**Havco Oil and Gas Inc.**  
1842 Eastbrook Road  
New Castle, Pa 16101

**October 10, 2011**

**Mr. S. Stephen Platt  
United States Environmental Protection Agency  
Region III  
1650 Arch Street  
Philadelphia, Pennsylvania 19103-2029**

**I apologize for taking so long to respond to your correspondence of August 11, 2011 concerning Stnehaven Energy Management, LLC's application for a Produced Water Disposal permit. Permit ID PAS2D01BVEN. For a period of time it was believed that a completely different candidate was going to have to be selected for this project. This was due to issues involving the surface casing in the proposed Latshaw #9 well. A plan has been reviewed with you that will allow the Latshaw #9 to once again be proposed as a candidate for produced water disposal. It will be discussed in this response to your requests in the order that you requested them:**

Figure G5D

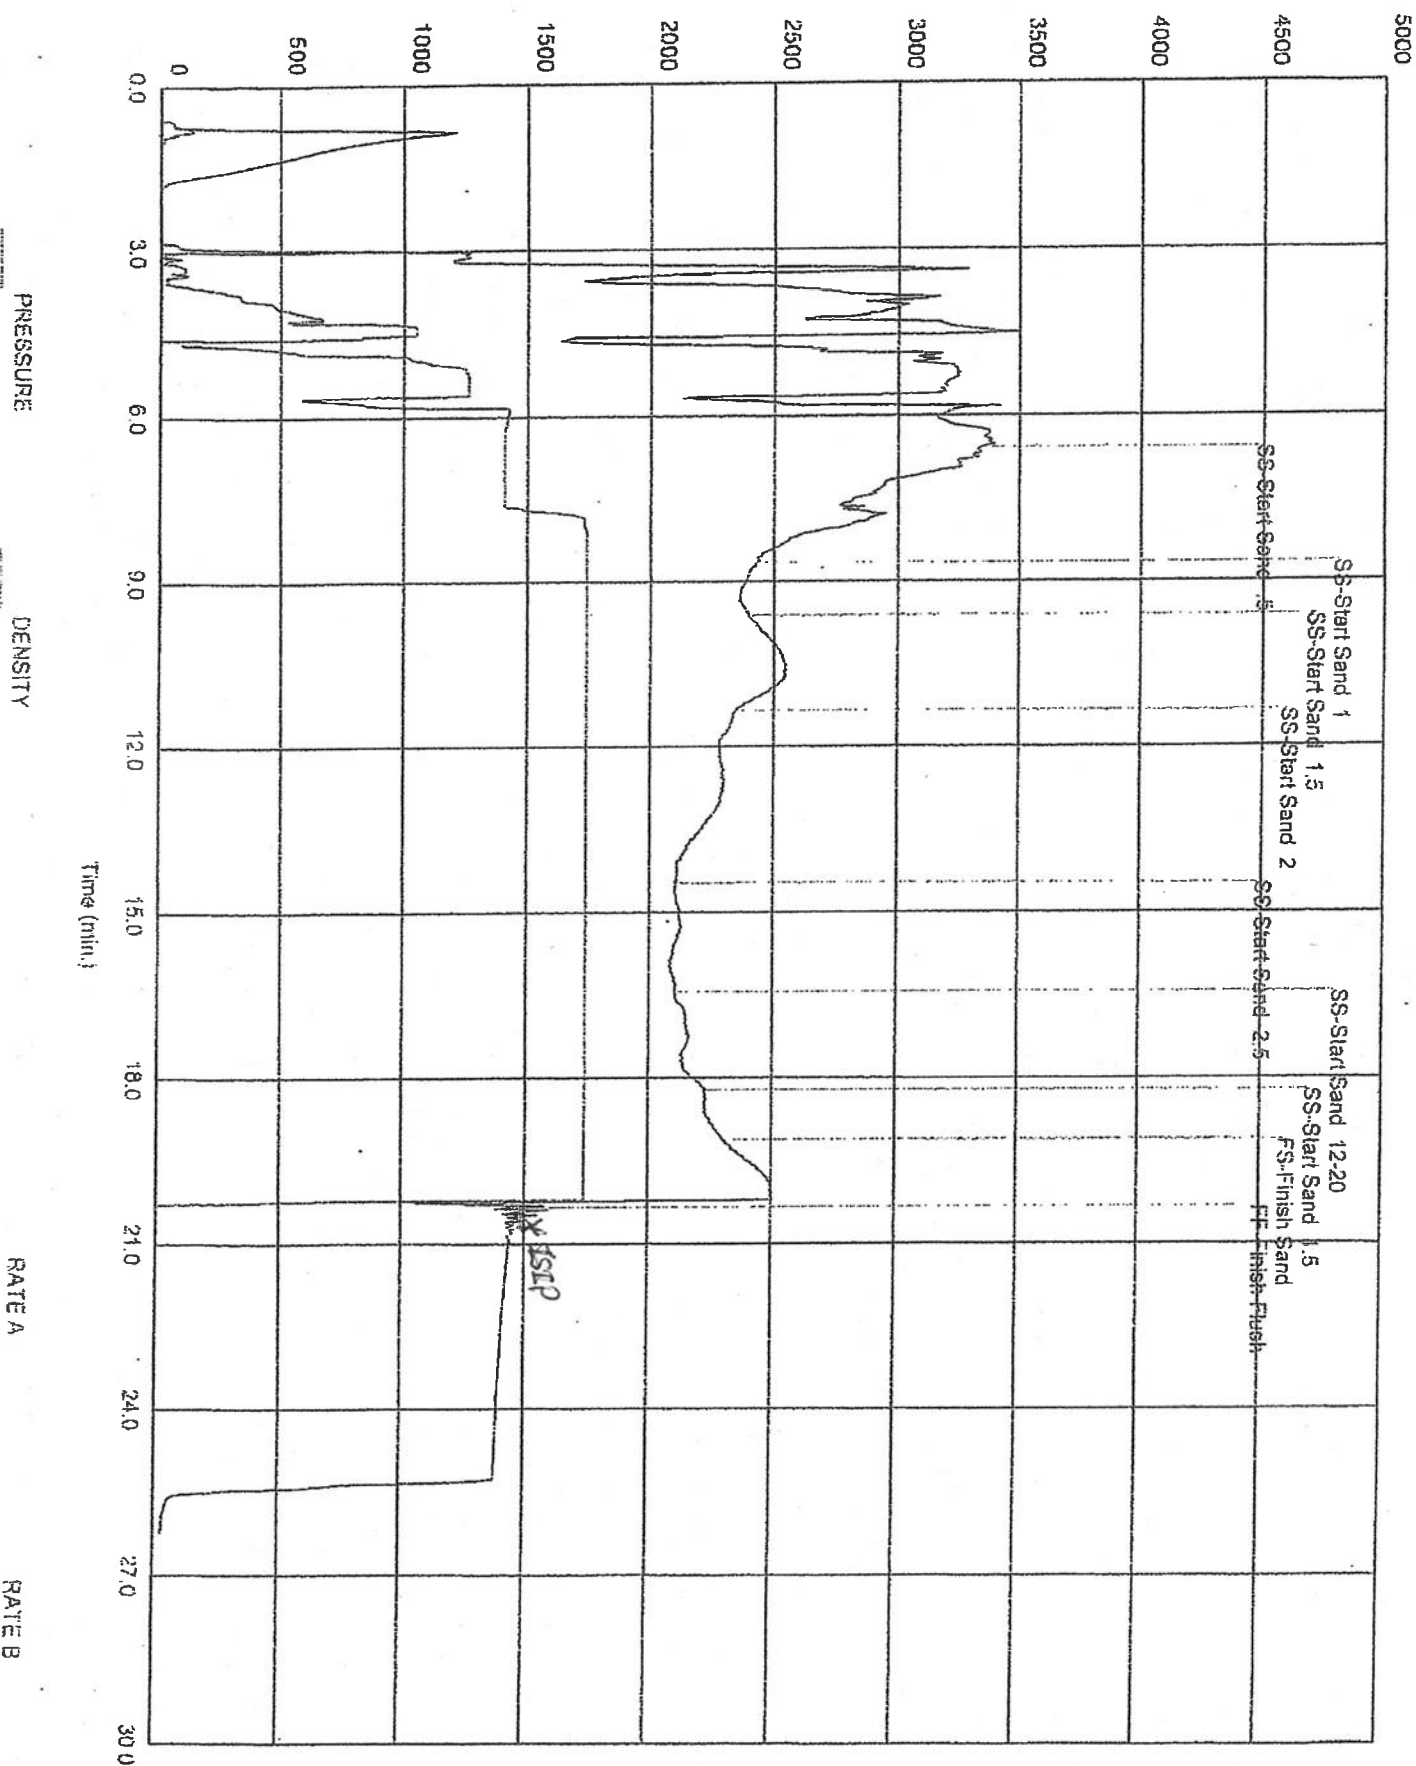
Figures G5A,B,C,and D are submitted and will be made part of the application. They display the pressure and rate information that was recorded during the fracture stimulation of the Speechley in The Latshaw #9. Two zones were treated in the well, 1978 and 1984. The pressure /rate curves indicate the zone at 1978 broke down @ 3250 psi while the one at 1984 broke down @ 3500 psi. The ISIP was 1435 for the zone at 1978 and 1477 for the zone at 1984.

Figure K1

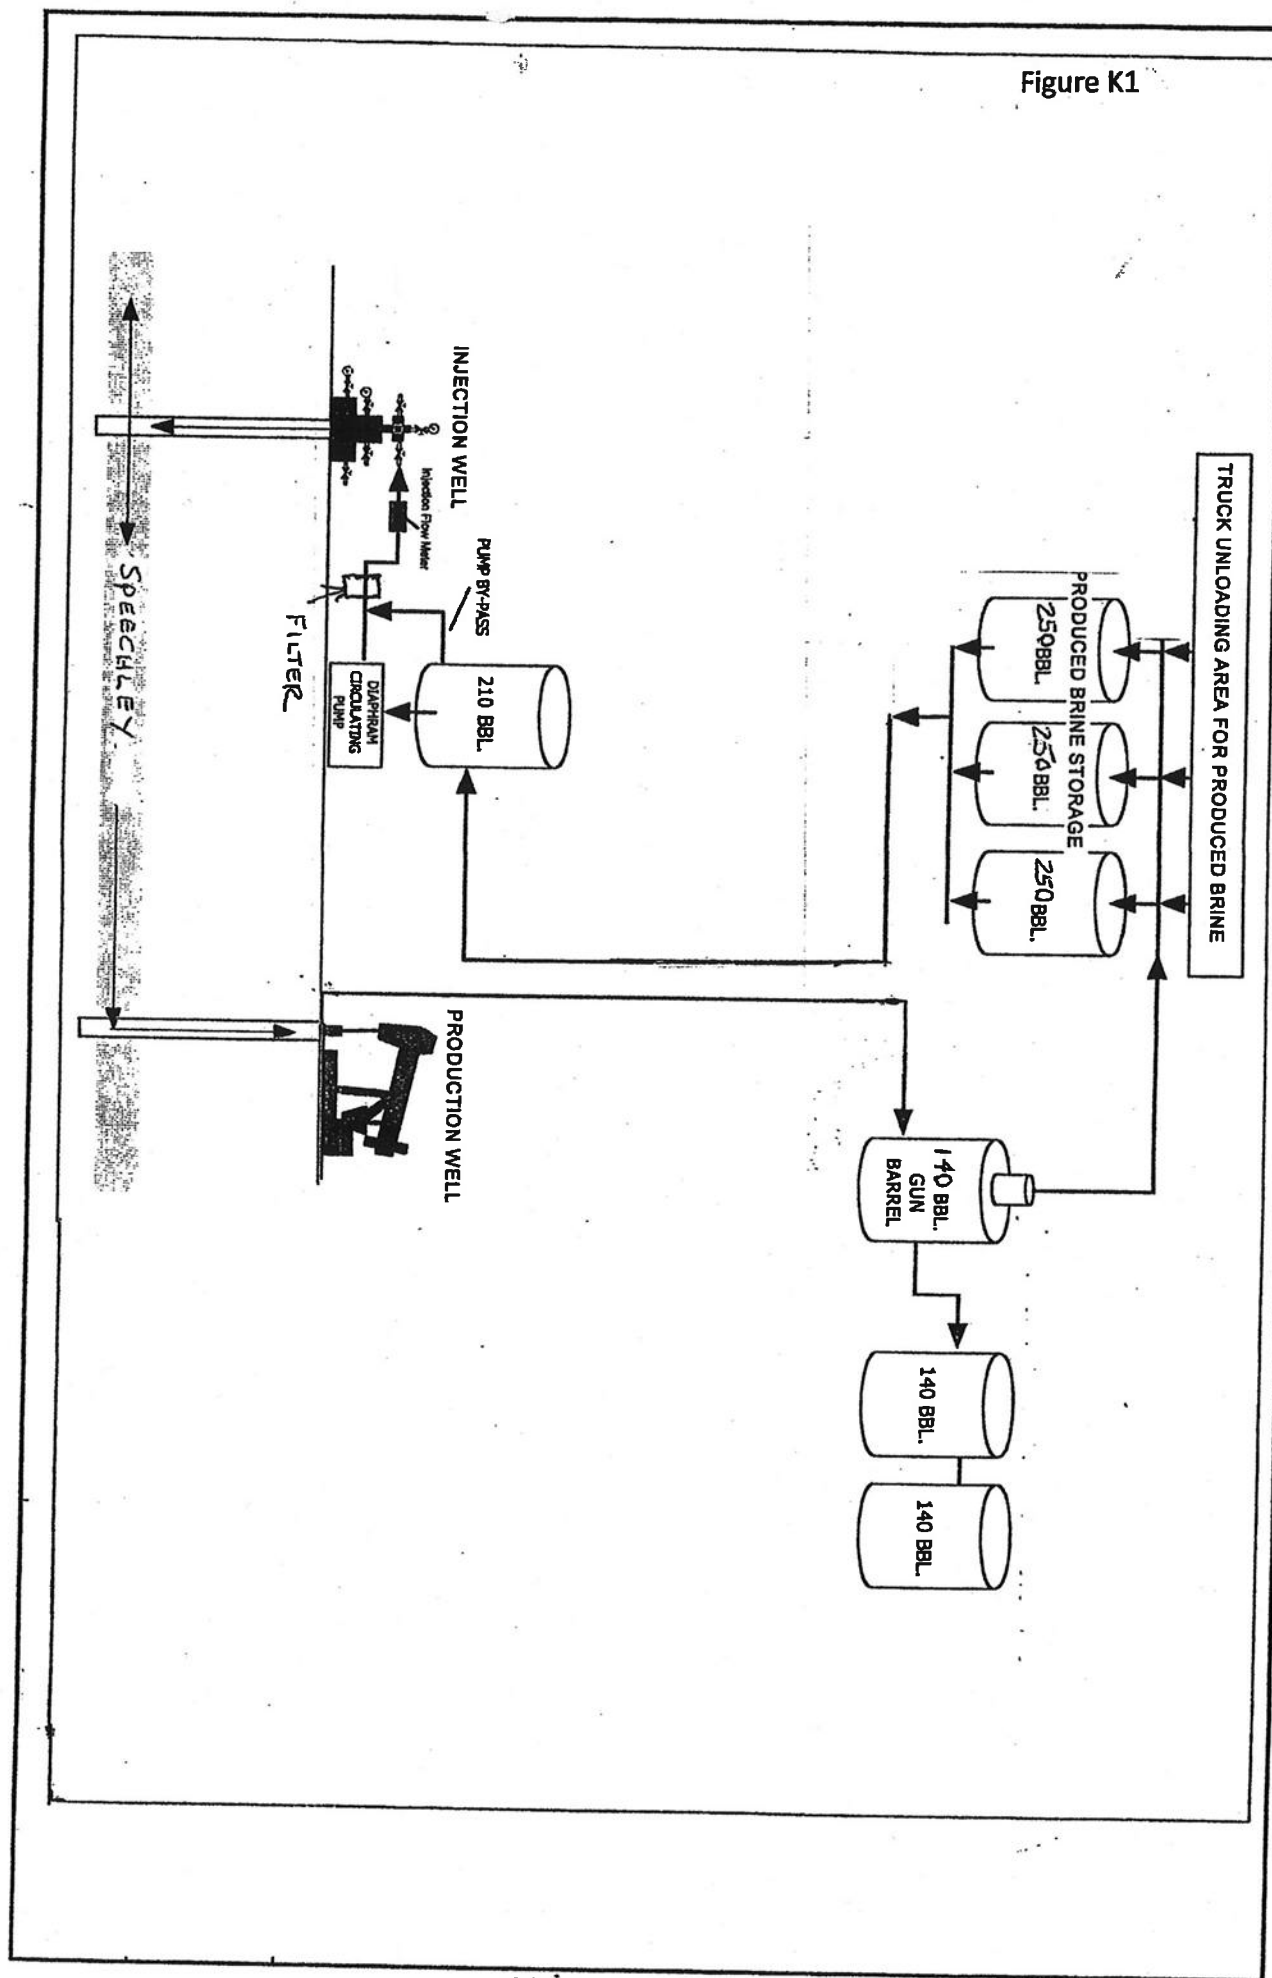
Initially a chain link fence will be installed around the well only. It will be inspected and monitored daily by Stonehaven personnel. In the event that a tank and pump have to be constructed at the well site the fence will be expanded to include all of the facilities. The tank would be diked and lined with a 20 mill pit liner. Figure K1 is a schematic showing a flow diagram of the Latshaw tank battery. An identical system exists on the Stover property. A gravity system will bring the water from the three storage tanks to the Latshaw #9. Map B3 show the location of both systems and the water lines transporting the brine to the Latshaw #9. The schematic shows a storage tank and pump at the well site although it is not anticipated to be necessary initially.

Figure M1

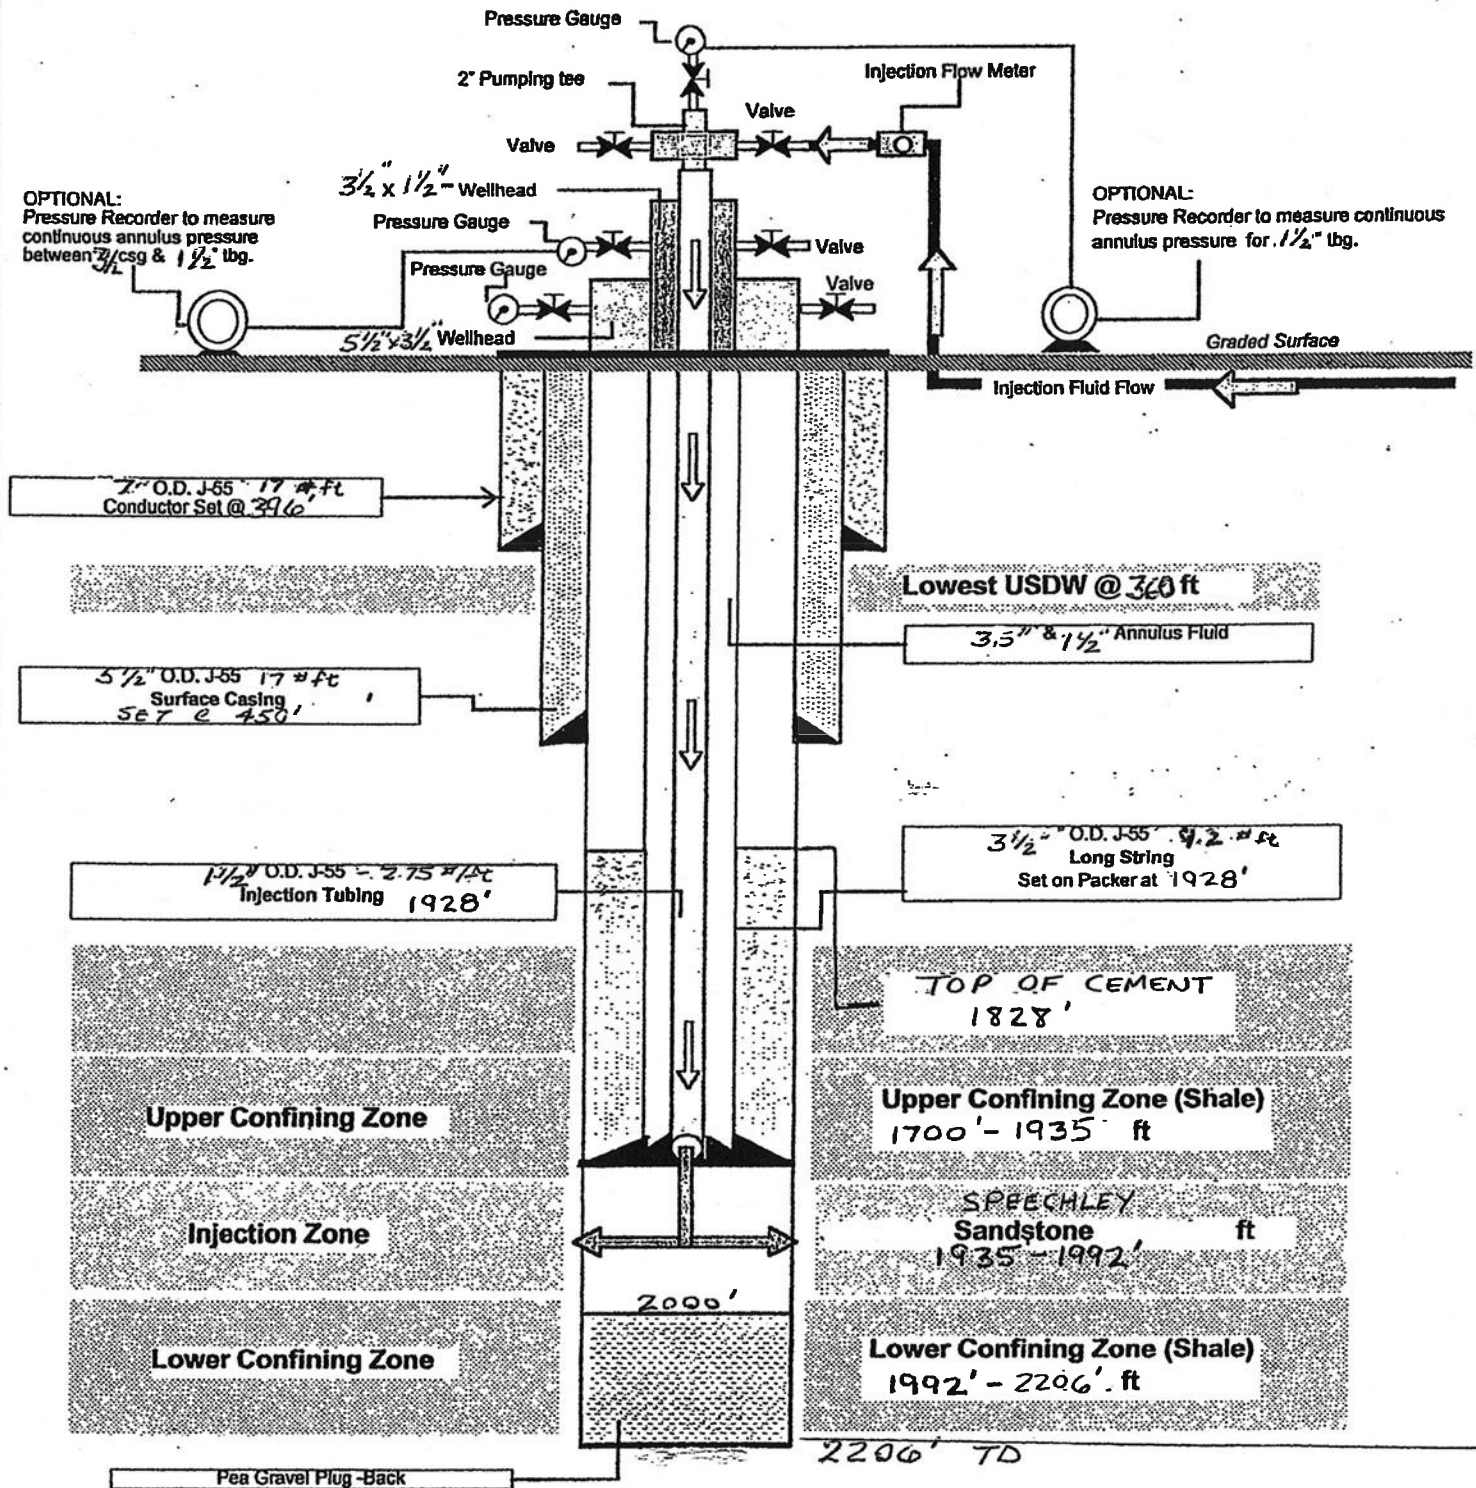
Upon review of the Latshaw #9 well construction it was determined that the surface casing was only set 36' below the Mountain sand. The bottom of the Mountain sand in the Latshaw #9 was 360' while the bottom of the 7" surface casing was at 396'. The cementing report also indicated that cement was not circulated to the surface during the job.

It is proposed to use the 7" casing as a conductor pipe and then cement a string of 5 ½" as the surface casing and cement it to the proper depth of at least 50' below the Mountain sand. That will change the well construction in that 3 ½" casing will replace the 4 ½" casing proposed in the original application as the cemented long string. 1 ½" tubing will replace the previously proposed 2 3/8" injection tubing. The enclosed Figure M1 shows the changes and it replaces the Figure M1 found in the original submission.

A new figure M1 is supplied and will be made a part of the application. The construction details discussed in Attachment M will be modified to reflect the changes. An open hole log for the Latshaw #9 is submitted as per you request. A bond log will be run and submitted on the 3 ½" casing string after it is cemented in place.
